Access Compliance Report Public Rights-of-Way (Curb Ramps)

Main Street: MCFADDEN_AVE Cross Street: VAN_BUREN_ST Location: NW

ADA ID: RPRK210930130643 Ramp Type: Type 1 - Perpendicular Diagonal Initial Pass/Fail: Fail Overall Compliance: No Severity Score: 2

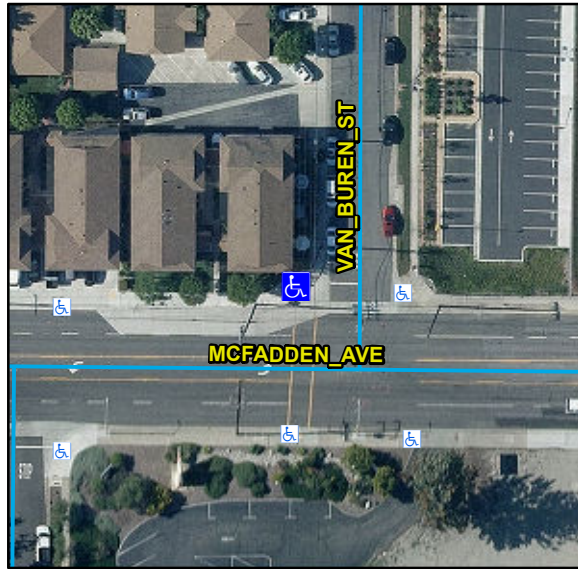
Compliance	Description	Data	Compliance	Description	Data
N/A	Ramp Length (in)	126	N/A	Flare Type LT	
Yes	Ramp Width (in)	48			N/A
Yes	Ramp Run Slope (%)	7.4	N/A	Flare Slope LT (%)	N/A
No	Ramp Cross Slope (%)	2.4	N/A	Flare Traversable LT	N/A
N/A	Landing Present	N/A	N/A	Flare Type RT	
N/A	Landing Length (in)	N/A			N/A
N/A	Landing Width (in)	N/A	N/A	Flare Slope RT (%)	N/A
N/A	Landing Run Slope (%)	N/A	N/A	Flare Traversable RT	N/A
N/A	Landing Cross Slope (%)	N/A	N/A	DWS Provided	N/A
N/A	Landing Movement Obstructed?	N/A	N/A	DWS Contrast	N/A
	Landing Movement Type	N/A	N/A	DWS Length (in)	N/A
N/A	Landing Shared	N/A	N/A	DWS Full Width	N/A
N/A	Clear Space	Yes	N/A	DWS Offset Left (in)	N/A
N/A	Clear Space To Crosswalk (in)	N/A	N/A	DWS Offset Right (in)	N/A
N/A	Marked Crosswalk 1	Yes	N/A	Marked Crosswalk 2	No
	Crossing 1 Direction	S		Crossing 2 Direction	E
	Marked Crosswalk 1 Width (in)	140		Marked Crosswalk 2 Width (in)	N/A

Remove & Replace Curb Ramp With Two New Directional Ramps or Equivalent.

R304.2.2, R304.5.3, STD 1115
